Office Action Summary

10/631,049

RANDAZZO, CHRISTOPH
STEFAN

DETAILED ACTION

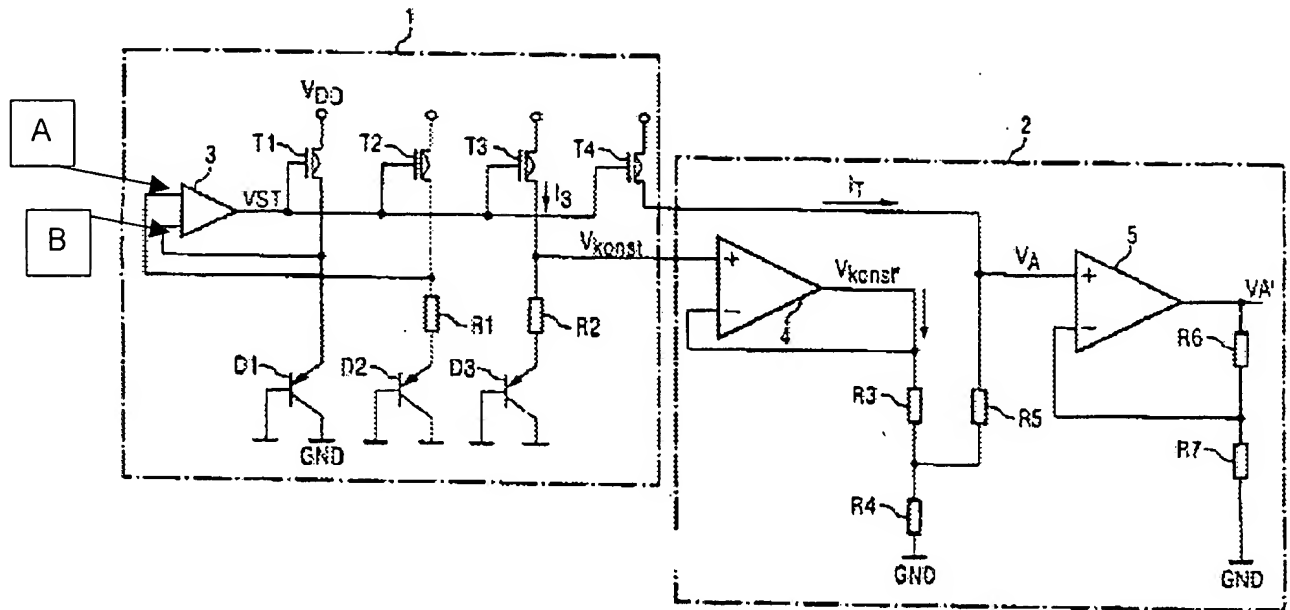
EGERER discloses or suggests all the limitations as claimed by Applicant in Claims 1-4, 9, 10 and 12-18, including an apparatus 1 for performing a temperature measurement function, comprising a first stage with a first circuit (D2, T2; see the Figure, reproduced on next page) and a second circuit (D1, T1) being arranged in parallel, said first circuit comprising a first transistor (T2), a first resistor (R1), and a parallel arrangement of n diodes (D2), said second circuit comprising a second transistor (T1) and a parallel arrangement of m diodes (D1), an operational amplifier (3) on the input side being connected to the first circuit and the second circuit, said operational amplifier (3) applying a gate voltage to said first transistor (T2) and said second transistor (T1), said apparatus 1, further comprising an output stage (2) with p output transistors (T4), and an output resistor (R5) performing a current to output voltage conversion (VA) in order to provide an output voltage that depends on the actual temperature as claimed by Applicant in Claim 1.

EGERER further discloses first transistor (T2) provides a first current flowing through the parallel arrangement n diodes (D2) and said second transistor (T1) provides a second current flowing through the parallel arrangement of m diodes (D1) as claimed by Applicant in Claim 2.

EGERER further discloses said operational amplifier 3 has a first input (not labeled in EGERER, but annotated "A" in reproduced Figure, above), a second input (annotated "B" in reproduced Figure, above), and an output (VST), the first input (A) being connected to a drain of the first transistor (T2) and the second input (B) being connected to a drain of the second transistor (T1), said output (VST) being connected to a gate of said first transistor (T2) and a gate of said second transistor (T1) for biasing these transistors (T2, T1) as claimed by Applicant in Claim 3.

EGERER further discloses said output stage 2 amplifies said[sic] first current to obtain a third current (I_T) before performing said current to output voltage conversion by converting said third current (I_T) into said output voltage (A) as claimed by Applicant in Claim 4.

EGERER further discloses the gate voltage is applied to gates of the p output transistors (T4) as claimed by Applicant in Claim 13.

EGERER further discloses a temperature compensation network (comprising elements R2 and D3) providing a bandgap reference voltage (V_{KONST}) at another output as claimed by Applicant in Claim 14.
